RE: Marion Co for Harleton WSC
TxCDBG Water Main Improvements
CDV23-0309
Change Order No. 1 Justification Letter

MARION CO. FOR HARLETON W.S.C.
TxCDBG WATER MAIN IMPROVEMENTS
CHANGE ORDER NO. 1 PROJECT MAP

Construction Contract Change Order

Change Order No.: 1

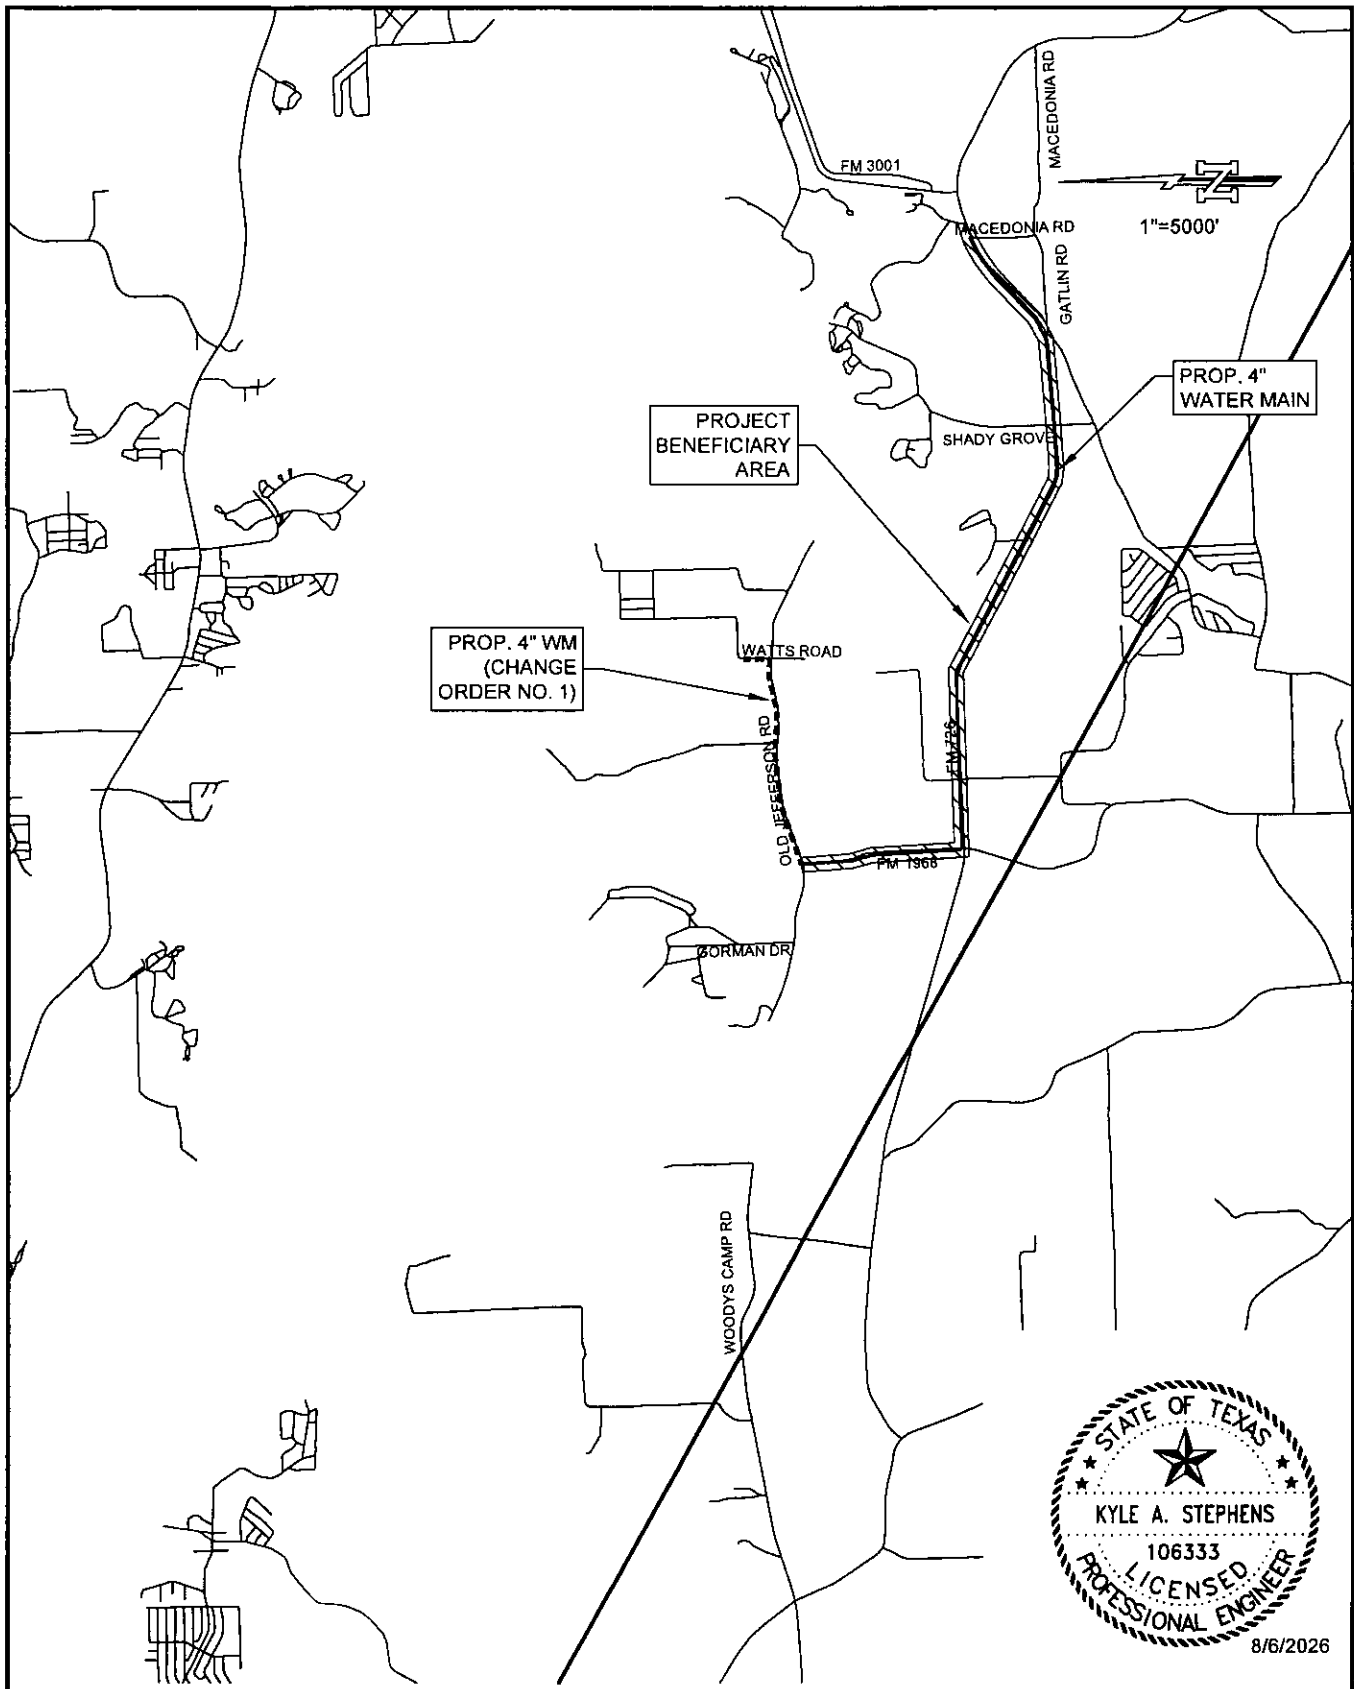
Please accept this letter as justification for the change order request for the above-referenced project. As we near completion of the original project's scope, additional operational improvements have been identified for the project that benefits the original project beneficiaries. The proposed 4" water main that ended on the north portion of the project would benefit from extending the water main eastward to a location on Watts Road that will complete a loop and eliminate the need for routine regular flushing of the newly constructed line. This connection and elimination of a dead-end main will provide the project beneficiaries' operational redundancy and limit the amount of customers' water pressure impact during routine flushing operations.

The proposed project does not increase the project beneficiaries. No new connections will be added to the line and the extension eastward will be for looping purposes only. The additional items included by change order are shown as new. However, unit prices were utilized from the base bid pricing provided in the original bids. These prices were competitively bid at that time.
